SERVICE BULLETIN

N° 139-685

ATA 93 - AIRCRAFT SURVIVABILITY EQUIPMENT (ASE) MODIFICATION

This Service Bulletin is issued in order to provide the necessary instruction on how to perform the FLIR variant for kit ASE P/N 3G5311A59011 and the ASE complete provision P/N 3G9350A08112.

Figure 10

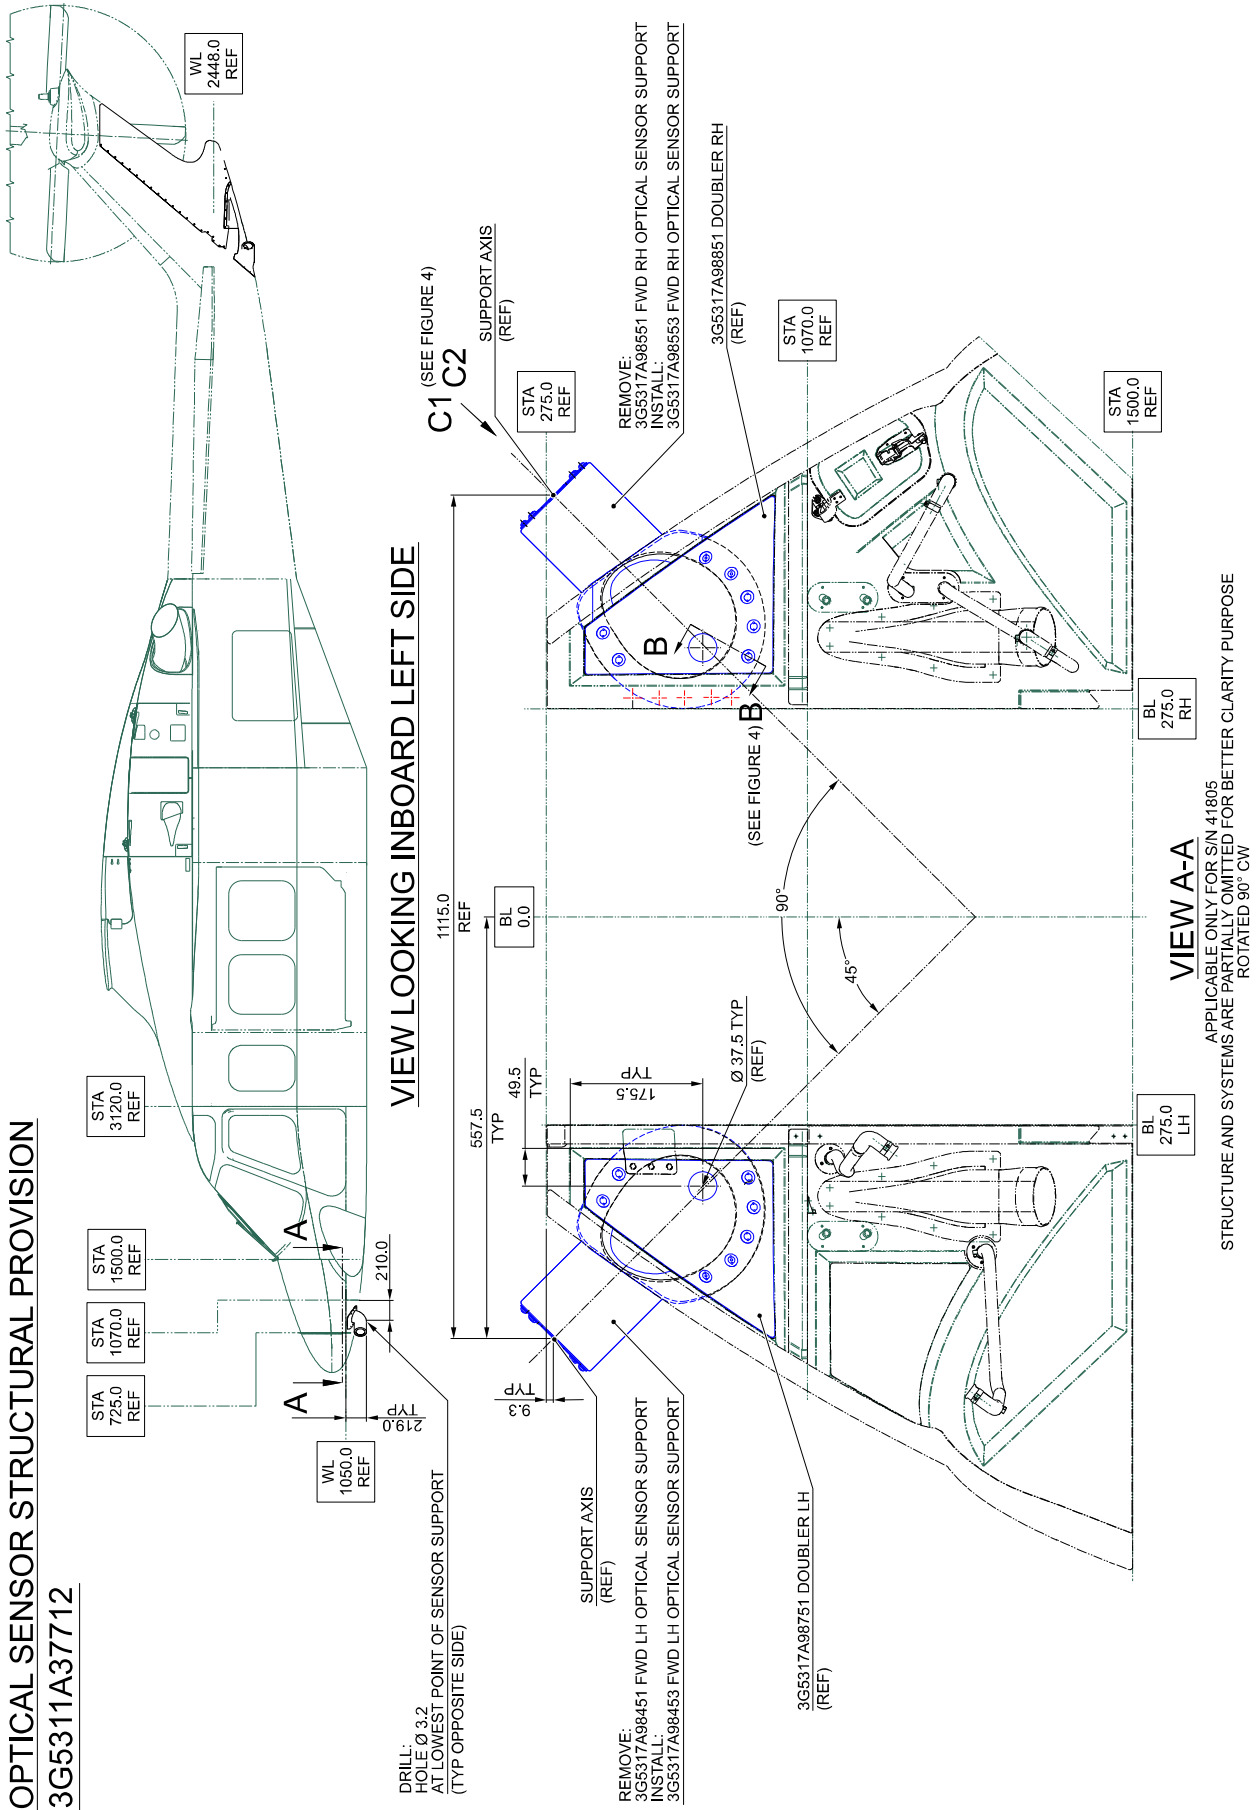
- 11.1 In accordance with AMP DM 39-A-08-21-00-00A-028A-A, level the helicopter.
 - 11.2 With reference to Figure 10 View A-A and Figure 11 Section B-B, remove the FWD RH optical sensor support P/N 3G5317A98551, n°7 screws P/N MS27039C1-08, and n°7 washers P/N NAS1149F0332P from the right lower panel P/N 3G5331A38331. Retain hardware for later reuse.

- 11.11 With reference to Figure 10 View Looking Inboard Left Side, drill the hole Ø3.20 thru the lowest point of the FWD RH optical sensor support P/N 3G5317A98553 in accordance with the dimensions shown.

Figure 11

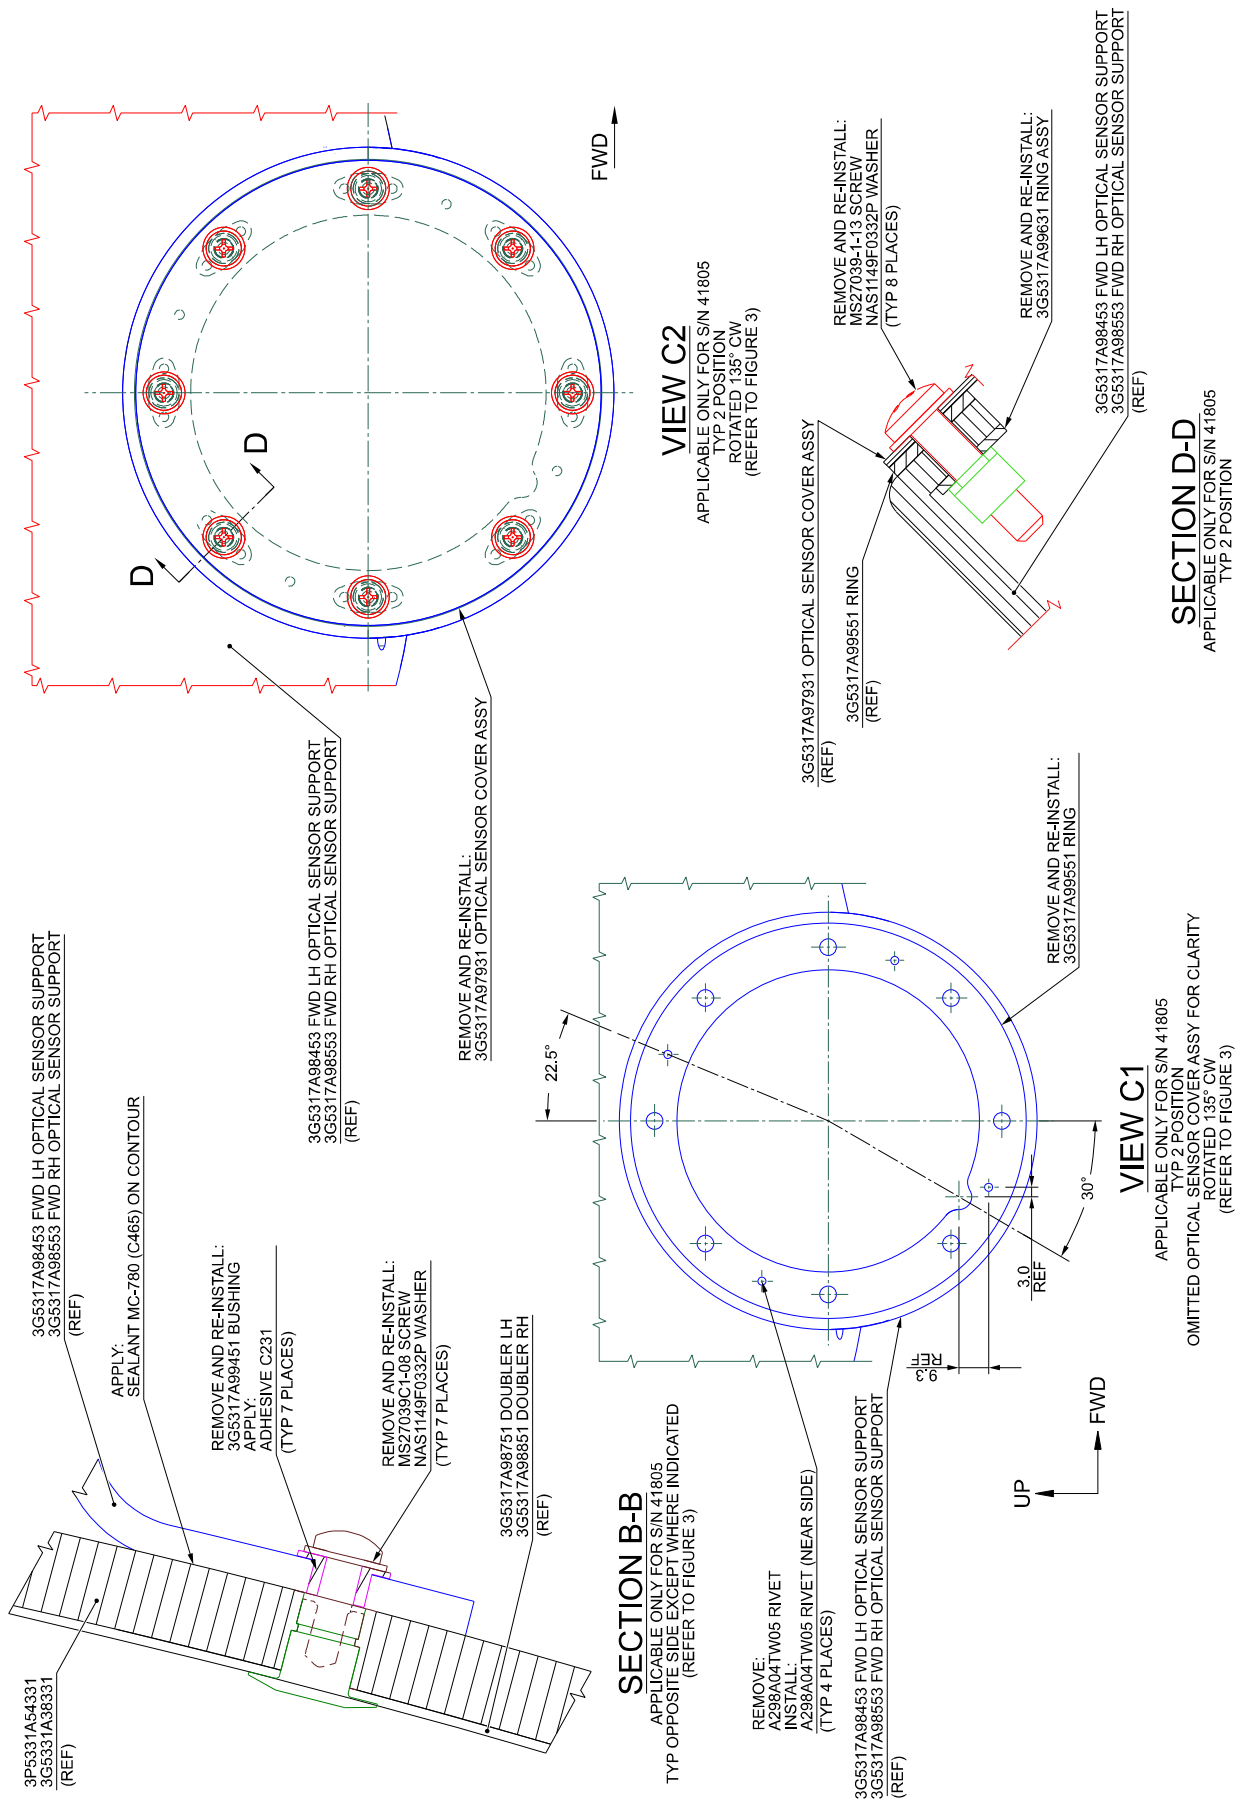
- 11.3 With reference to Figure 11 View C1/C2 and Section D-D, remove and retain for later reuse from the FWD RH optical sensor support P/N 3G5317A98551 the ring assy P/N 3G5317A99631, the optical sensor cover assy P/N 3G5317A97931, the fixing hardware (n°8 screws P/N MS27039-1-13 and n°8 washers P/N NAS1149F0332P) and the ring P/N 3G5317A99551; remove and discard n°4 fixing rivets P/N A298A04TW05.

- 11.6 With reference to Figure 11 View C1 and Section D-D, re-install the ring P/N 3G5317A99551 (previously removed at step 11.3) in the indicated position on the on the FWD RH optical sensor support P/N 3G5317A98553 by means of n°4 rivets P/N A298A04TW05.

- panel P/N 3G5331A38331 and install n°7 bushings P/N 3G5317A99451 by means of the adhesive C231.
- 11.8 With reference to Figure 11 View C1 and Section D-D, re-install the ring P/N 3G5317A99551 (previously removed at step 11.3) and the ring assy P/N 3G5317A99631 in the indicated position on the FWD RH optical sensor support P/N 3G5317A98553 by means of n°4 rivets P/N A298A04TW05.

Figure 12

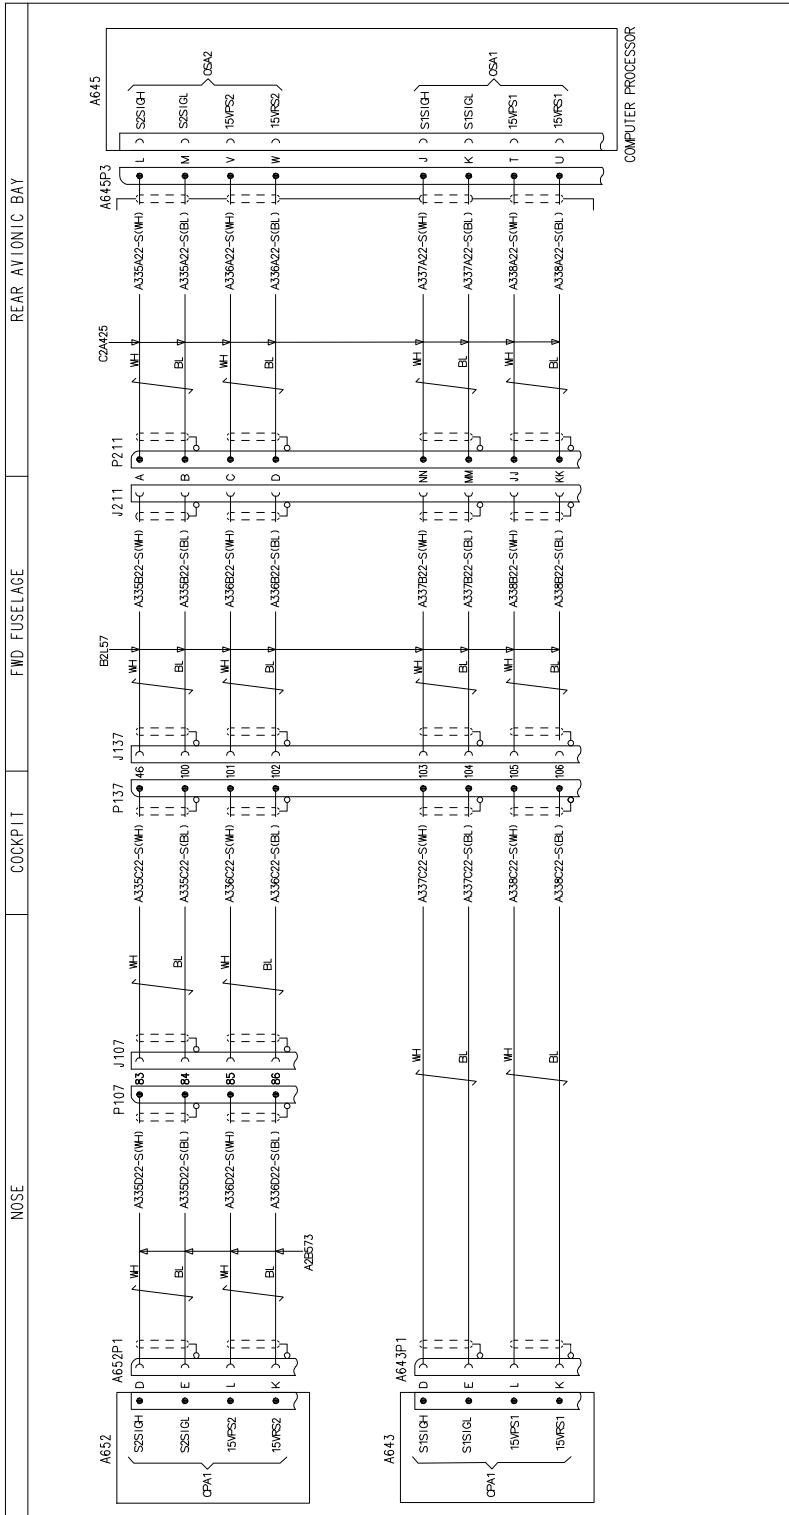
- 15.1.5 In accordance with AMP DM 39-A-20-10-08-00A-622A-A and with reference to Figure 12 Wiring Diagram and Table, perform the electrical connections between the connector A643P1 and the connector P137.

- 15.1.8 With reference to Figure 12 Wiring Diagram, install the insulation sleeveings P/N M23053/8-004-C on the end of the wires.
 - 15.1.9 In accordance with AMP DM 39-A-20-10-08-00A-622A-A and with reference to Figure 12 Wiring Diagram and Table, perform the electrical connections between the connector A643P1 and the connector P137.
